ADDENDUM NO. 1
November 28, 2022

HEALTH DEPARTMENT DRIVEWAY PROJECT
Project No. 2022-28

Bidders are hereby informed that the construction plans and/or specifications are modified as follows:

Sheet C2.01 has been revised with the addition of notes as follows:

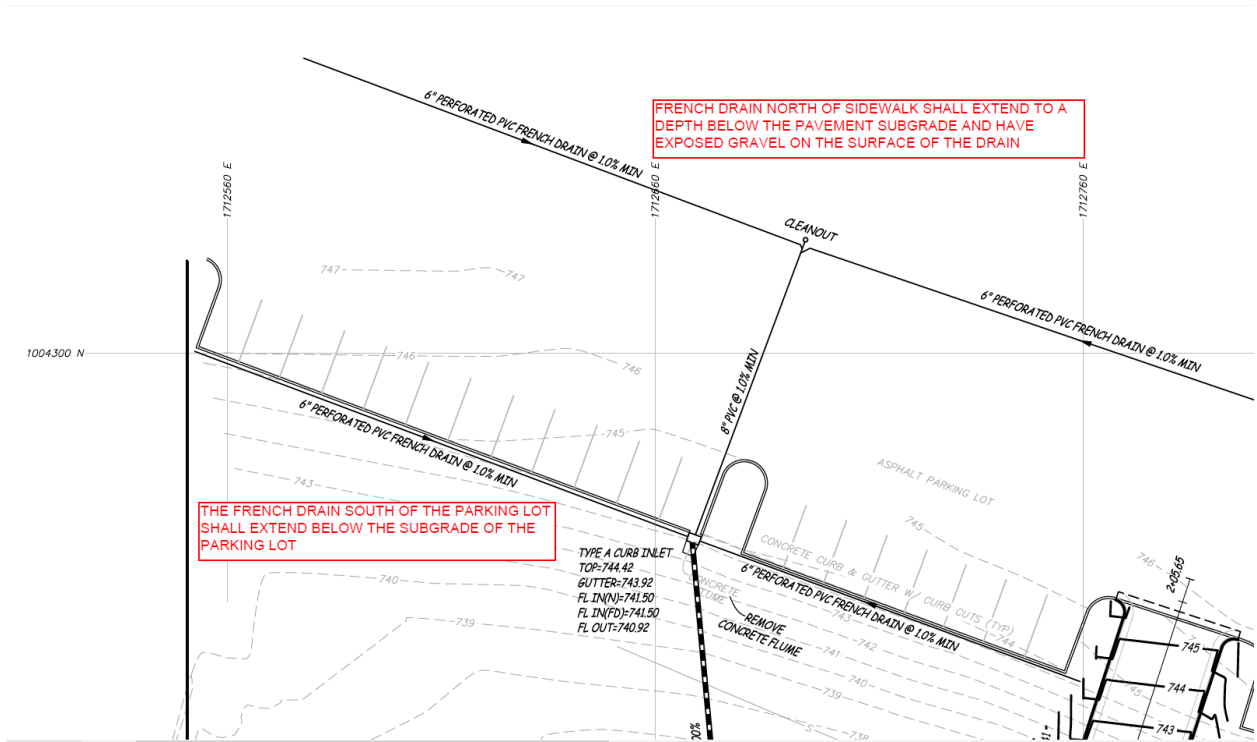
THE FRENCH DRAIN SOUTH OF THE PARKING LOT SHALL EXTEND BELOW THE SUBGRADE OF THE PARKING LOT

FRENCH DRAIN NORTH OF SIDEWALK SHALL EXTEND TO A DEPTH BELOW THE PAVEMENT SUBGRADE AND HAVE EXPOSED GRAVEL ON THE SURFACE OF THE DRAIN
